## PIC24FV32KA304 Family Silicon Errata and Data Sheet Clarification

The PIC24FV32KA304 family devices that you have received conform functionally to the current Device Data Sheet (DS39995B), except for the anomalies described in this document.

28-Pin SPDIP/SSOP/SOIC<sup>(1,2)</sup>

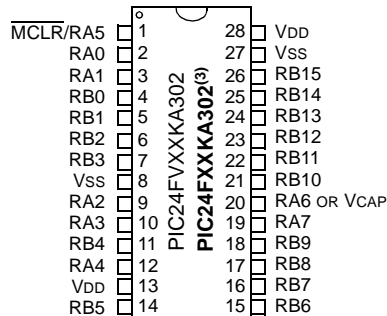
In the Pin Diagrams at the beginning of the data sheet, the following pinouts need to be modified. The correct pin changes are shown in **bold**; the bold in the original diagram is removed for clarity. All other information in the pin features remains unchanged.

3: **CTED1 has been removed from Pin 2 of the PIC24FXXKA302 device. There are no changes made to the PIC24FVXXKA302 pin features.**

Pin	Pin Features	
	PIC24FVXXKA302	PIC24FXXKA302
1	MCLR/Vpp/RA5	MCLR/Vpp/RA5
2	VREF+/CVREF+/AN0/C3INC/CTED1/CN2/RA0	<b>VREF+/CVREF+/AN0/C3INC/CN2/RA0<sup>(3)</sup></b>
3	CVREF-/VREF-/AN1/CN3/RA1	CVREF-/VREF-/AN1/CN3/RA1
4	PGED1/AN2/ULPWU/CTCMP/C1IND/C2INB/C3IND/U2TX/CN4/RB0	PGED1/AN2/ULPWU/CTCMP/C1IND/C2INB/C3IND/U2TX/CN4/RB0
5	PGEC1/AN3/C1INC/C2INA/U2RX/CTED12/CN5/RB1	PGEC1/AN3/C1INC/C2INA/U2RX/CTED12/CN5/RB1
6	AN4/C1INB/C2IND/SDA2/T5CK/T4CK/U1RX/CTED13/CN6/RB2	AN4/C1INB/C2IND/SDA2/T5CK/T4CK/U1RX/CTED13/CN6/RB2
7	AN5/C1INA/C2INC/SCL2/CN7/RB3	AN5/C1INA/C2INC/SCL2/CN7/RB3
8	Vss	Vss
9	OSCI/AN13/CLKI/CN30/RA2	OSCI/AN13/CLKI/CN30/RA2
10	OSCO/AN14/CLKO/CN29/RA3	OSCO/AN14/CLKO/CN29/RA3
11	SOSCI/AN15/U2RTS/CN1/RB4	SOSCI/AN15/U2RTS/CN1/RB4
12	SOSCO/SCLKI/U2CTS/CN0/RA4	SOSCO/SCLKI/U2CTS/CN0/RA4
13	VDD	VDD
14	PGED3/ASDA <sup>(1)</sup> /SCK2/CN27/RB5	PGED3/ASDA <sup>(1)</sup> /SCK2/CN27/RB5
15	PGEC3/ASCL <sup>(1)</sup> /SDO2/CN24/RB6	PGEC3/ASCL <sup>(1)</sup> /SDO2/CN24/RB6

16	U1TX/C2OUT/OC1/INT0/CN23/RB7	U1TX/INT0/CN23/RB7
17	SCL1/U1CTS/C3OUT/CTED10/CN22/RB8	SCL1/U1CTS/C3OUT/CTED10/CN22/RB8
18	SDA1/T1CK/U1RTS/IC2/CTED4/CN21/RB9	SDA1/T1CK/U1RTS/IC2/CTED4/CN21/RB9
19	SDI2/IC1/CTED3/CN9/RA7	SDI2/IC1/CTED3/CN9/RA7
20	VCAP	C2OUT/OC1/CTED1/INT2/CN8/RA6
21	PGED2/SDI1/OC3/CTED11/CN16/RB10	PGED2/SDI1/OC3/CTED11/CN16/RB10
22	PGEC2/SCK1/OC2/CTED9/CN15/RB11	PGEC2/SCK1/OC2/CTED9/CN15/RB11
23	AN12/LVDIN/SS2/IC3/CTED2/INT2/CN14/RB12	AN12/LVDIN/SS2/IC3/CTED2/CN14/RB12
24	AN11/SDO1/OCFB/CTPLS/CN13/RB13	AN11/SDO1/OCFB/CTPLS/CN13/RB13
25	CVREF/AN10/C3INB/RTCC/C1OUT/OCFA/CTED5/INT1/CN12/RB14	CVREF/AN10/C3INB/RTCC/C1OUT/OCFA/CTED5/INT1/CN12/RB14
26	AN9/C3INA/T3CK/T2CK/REFO/SS1/CTED6/CN11/RB15	AN9/C3INA/T3CK/T2CK/REFO/SS1/CTED6/CN11/RB15
27	Vss/AVss	Vss/AVss
28	VDD/AVDD	VDD/AVDD

## Pin Diagrams

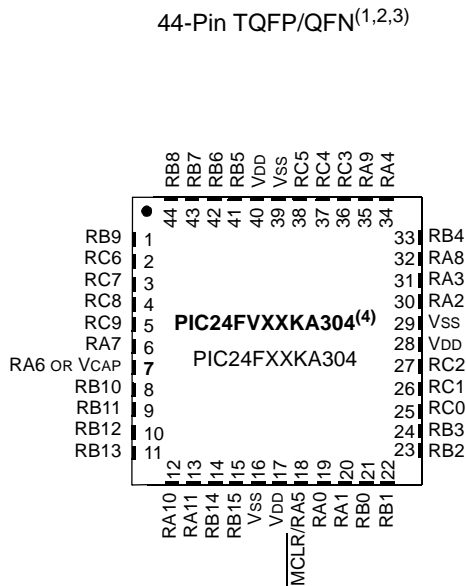
- Note 1: Exposed pad on underside of device is connected to Vss.
- 2: Alternative multiplexing for SDA1 (ASDA1) and SCL1 (ASCL1) when the I2CSEL Configuration bit is set.
- 3: PIC24F32KA304 device pins have a maximum voltage of 3.6V and are not 5V tolerant.
- 4: **The OC1 feature is included on Pin 43 of the PIC24FVXXKA302 device. There are no changes made to the PIC24FXXKA302 pin features.**

42	PGEC3/ASCL1 <sup>(2)</sup> /CN24/RB6	PGEC3/ASCL1 <sup>(2)</sup> /CN24/RB6
43	<b>INT0/OC1/CN23/RB7<sup>(4)</sup></b>	INT0/CN23/RB7
44	SCL1/U1CTS/C3OUT/CTED10/CN22/RB8	SCL1/U1CTS/C3OUT/CTED10/CN22/RB8
